Artery Plaza: Site Plan Amendment 81984002E

Staff Report Date: 10.15.18

Site Plan Amendment No. 81984002E

Figure 3 – Site Plan Amendment

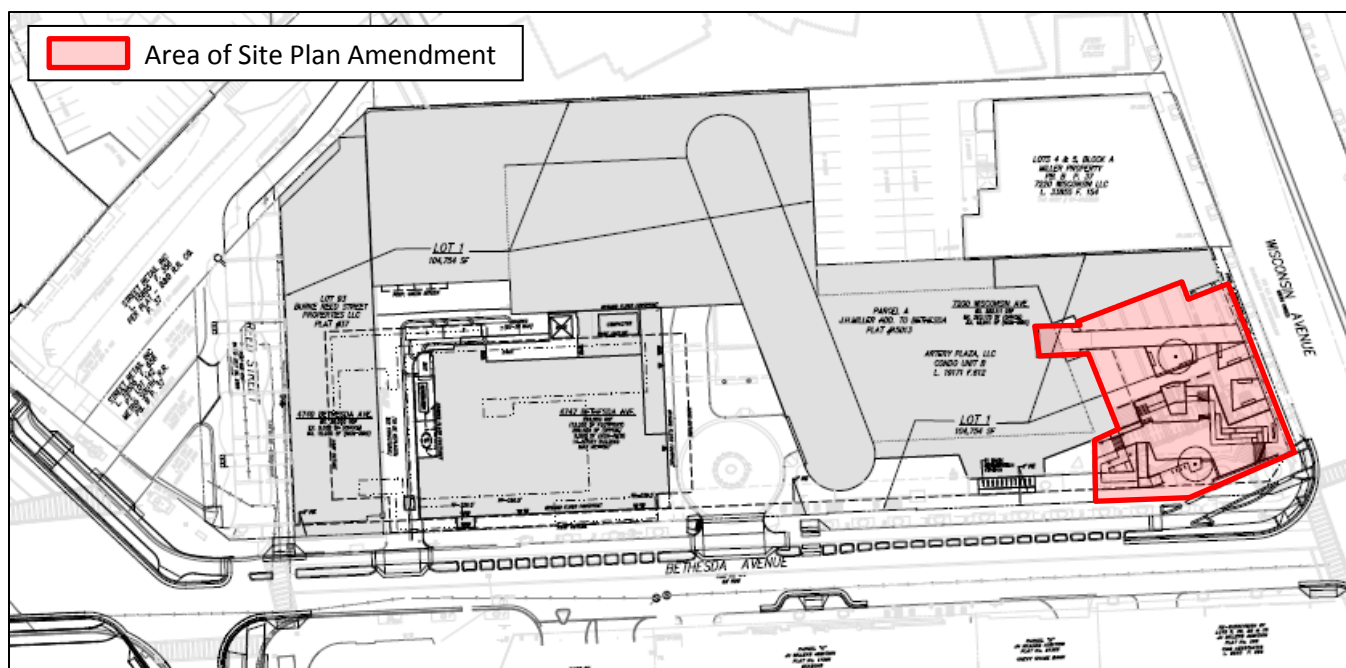
Site Plan Amendment No. 81984002E for the Property allows for improvements to the plaza located at the corner of Wisconsin Avenue and Bethesda Avenue (Figure 3). The redevelopment of the plaza at this time is triggered in large measure by Montgomery County Department of Transportation's (MCDOT) plans to construct a portion of the Capital Crescent Trail across the southeast corner of the plaza, as discussed in the Mandatory Referral section above, which will require a certain level of coordination with the Applicant to ensure that the grade of the plaza adjacent to the CCST ties in appropriately. While the subject Site Plan includes the improvements proposed by MCDOT to accommodate the CCST, the Site Plan delineates this portion of the Property and notes that the improvements will be conducted by MCDOT.

Figure 9 – Proposed Art Location

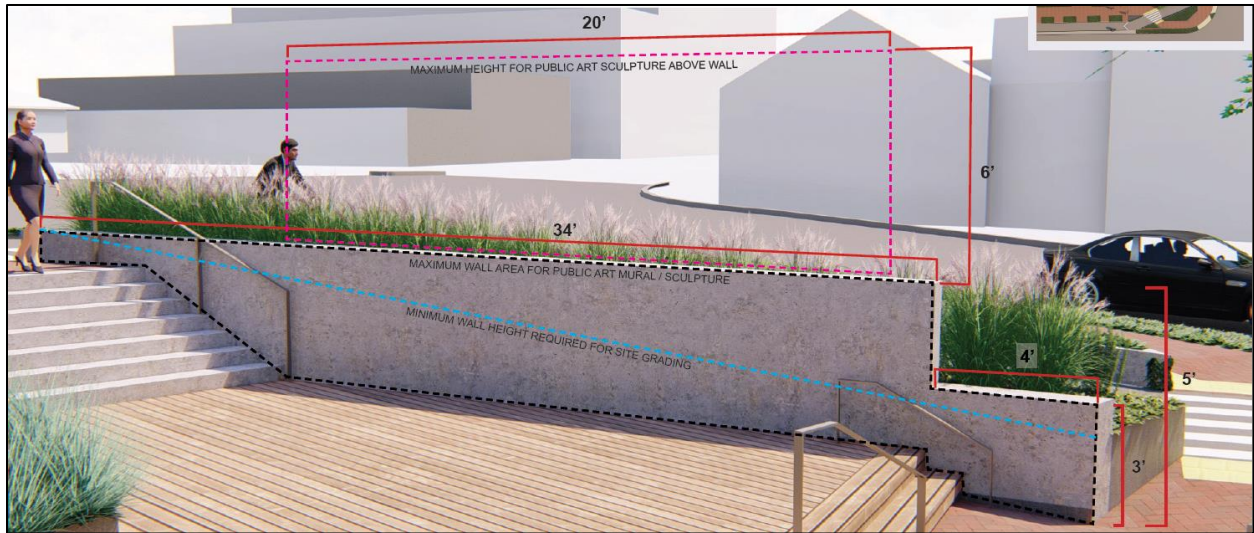
The Art Review Panel recommended that the two art pieces not be removed unless some type of art form is reinstated in the plaza. In response to the Art Review Panel, the Applicant is proposing to include a new art component in the renovation of the plaza. The Applicant proposes providing a public art wall on the upper portions of the southern façade of the retaining wall located to the north of the CCST and to continue this concept on the entire face of the northern façade of the retaining wall (Figures 9-11). The southern façade would be viewed by individuals passing by the Property, while the northern façade will be enjoyed by those within the plaza.

- a. The Applicant must provide public art to be located in the vicinity of, or integrated into, the retaining wall and/or planter bed located to the north of the CCST so that the art is visible from both within the plaza when viewed from the north and from the sidewalk and CCST when viewed from the south.

Figure 10 – Site Circulation

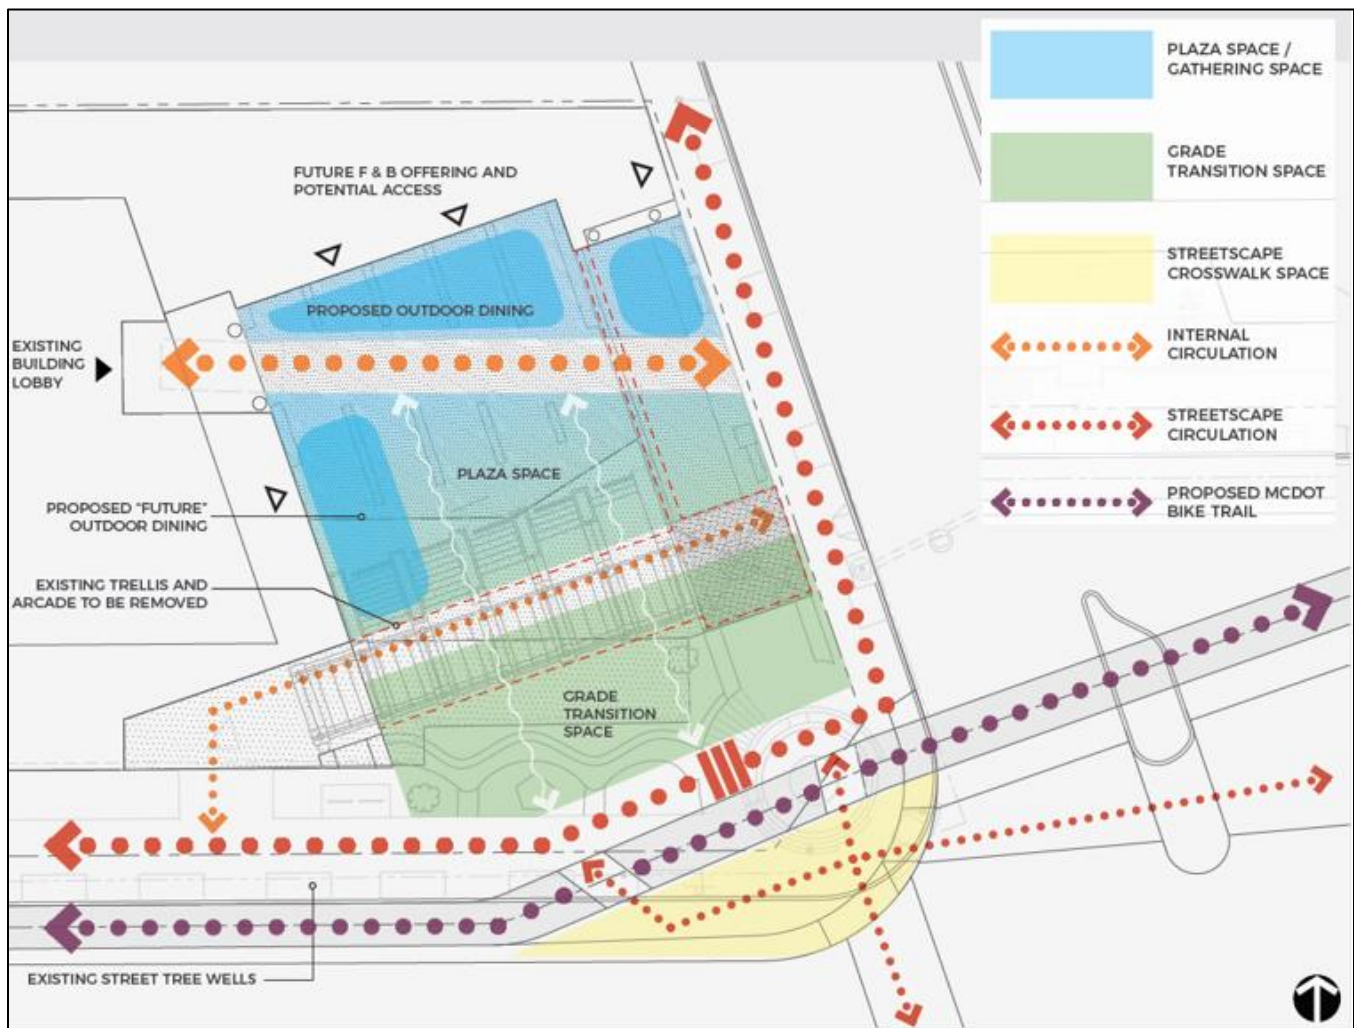
Pedestrian access into the redesigned plaza will be via the plaza's public street frontages on both Bethesda Avenue and Wisconsin Avenue. Since the redesigned plaza is responding to existing vertical structures within the space (i.e., the roof of the underground parking garage and building substructure), the plaza drops approximately eight feet from north to south. As a result of the plaza's grade change, the accessible pedestrian route between the upper and lower portions of the plaza will be on the adjacent public sidewalk network. (Figure 10)
